Nicolet Townhouse Cooperative Grounds Committee
Joliet Townhouse Cooperative Grounds Committee

May 13, 2025

Detroit Historic District Commission
Planning and Development Department
Coleman A. Young Municipal Center
2 Woodward Avenue, Suite 808
Detroit, MI 48226

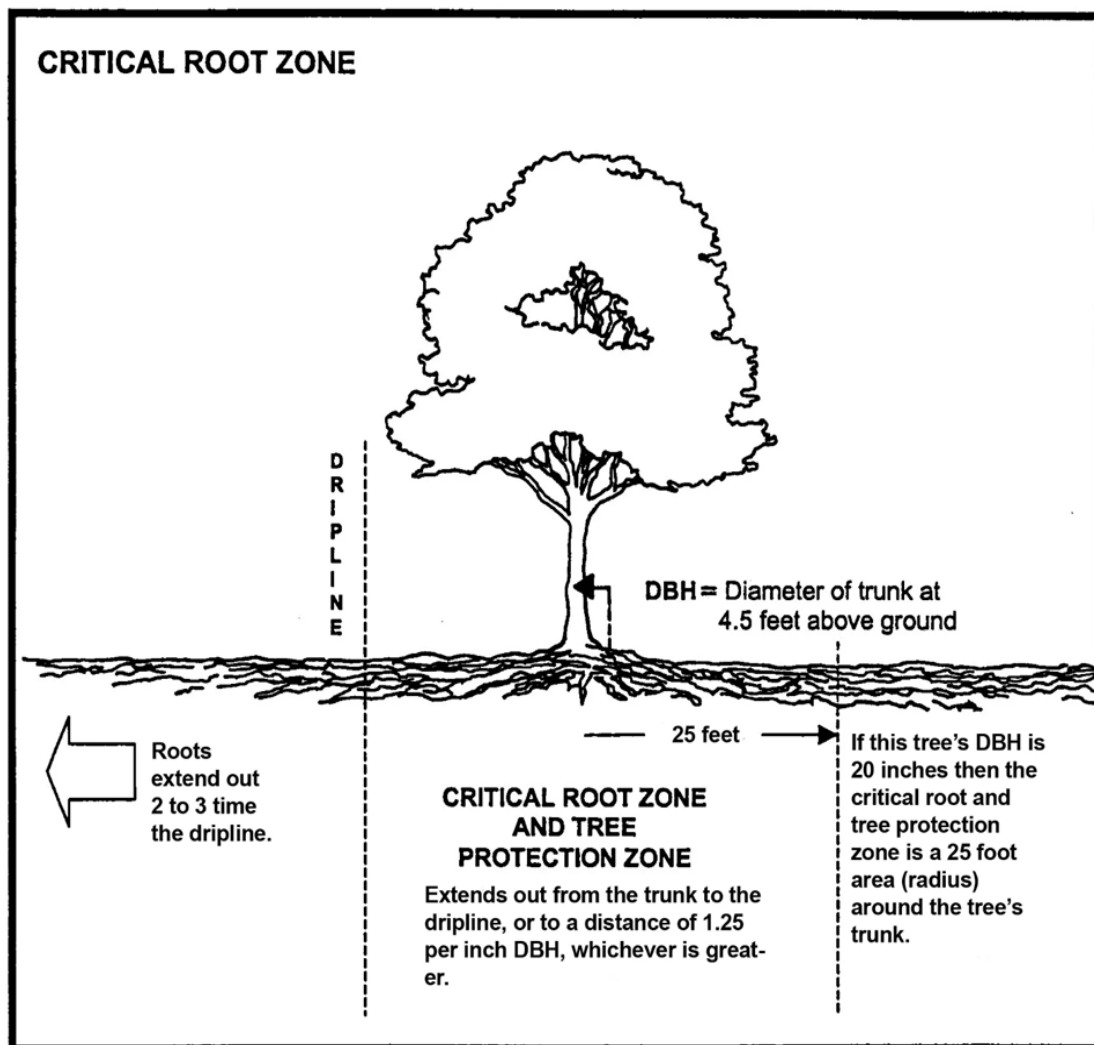
2. Excavation will destroy mature trees and shrubs that have "Critical Root Zones" within the excavation sites.

The "Critical Root Zones" (CRZ) of many mature trees and shrubs exist within the excavation sites (see explanation below). While the trunks and foliage of these trees and shrubs do not sit within the excavation sites, their roots that are critical for their survival are located within the excavation sites. As excavation removes the critical roots of these trees and shrubs, they will be destroyed.

There are at least 12 mature trees with Critical Root Zones that would fall within Detroit Thermal's proposed excavation sites. As these trees die, they will be at great risk for their root systems to become unstable causing the trees to fall. Thus, in addition to the destruction of this natural and cultural resource, damage caused to these trees through excavation would create a safety hazard, risking lives, and increasing liability, resulting in increased costs for our co-op members.
